CITY OF SOMERVILLE, MASSACHUSETTS
STRATEGIC PLANNING AND COMMUNITY DEVELOPMENT
JOSEPH A. CURTATONE, MAYOR

Case #: ZBA 2008-71
Date: May 5, 2009
Recommendation: Conditional Approval

PLANNING STAFF REPORT

Site: 22 Benedict Street

22 Benedict St: Existing Porch (left), Proposed Porch (right)

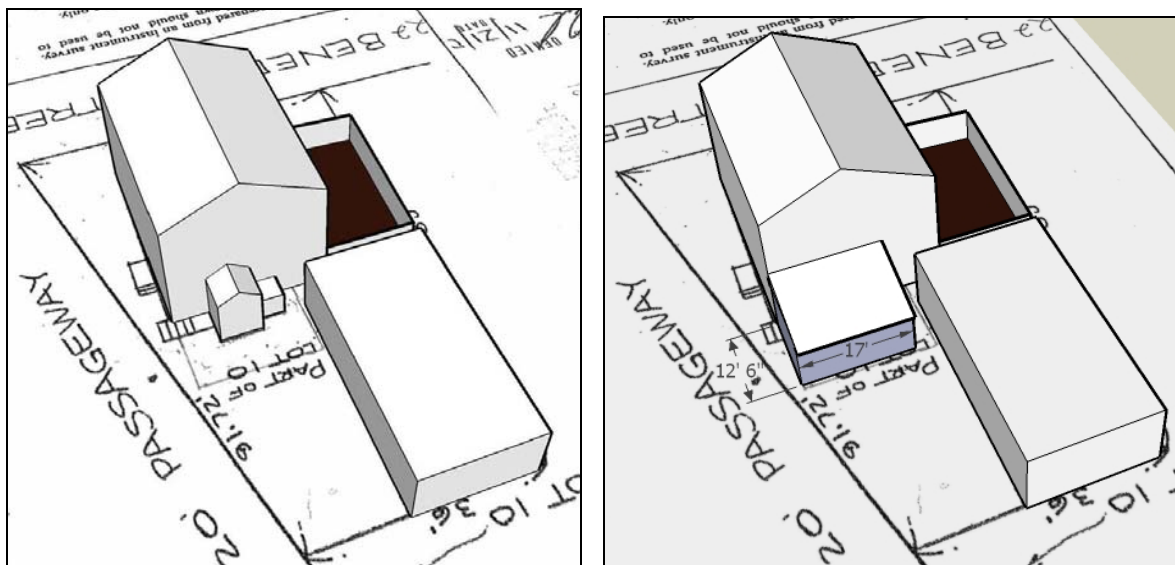
2. Proposal: The proposal is to construct a two-story, 17.5' by 12.5', addition in the rear of the dwelling. Due to the slope of the site, the first story would be at the basement level and it would be used for storage. The second story of the porch would be enclosed and would align with the first story of the house. The Applicant has previously submitted drawings that were difficult to read and contained errors, and Staff had recommended Denial. In consultation with Staff, the Applicant has submitted revised drawings that are a significant improvement. These illustrate a three-foot space between the addition and the existing garage, which would provide access to the side yard and allow maintenance of the structures. The new drawings show the porch covering a portion of an existing window, which Staff recommend requiring it to be replaced with a smaller window or filled in. The revised drawings also illustrate a sloped roof over the new porch, which is an improvement. A small portion of the stairway would be located outside the structure, with the remaining stairs located inside. Staff has created the following image to illustrate the spatial relationship of the porch to the garage.

5. Impacts of Proposal: The garage is currently in poor condition; openings are covered with plywood and a rusty door. The proposed addition would block some of the garage from view. The existing porch is sided with plywood on the basement level and has not weathered well. Staff recommend that final material choices be subject to staff approval.

Nevertheless, final details, included materials selection, location of trim, and window size and placement, should be coordinated with Planning Staff prior to construction.
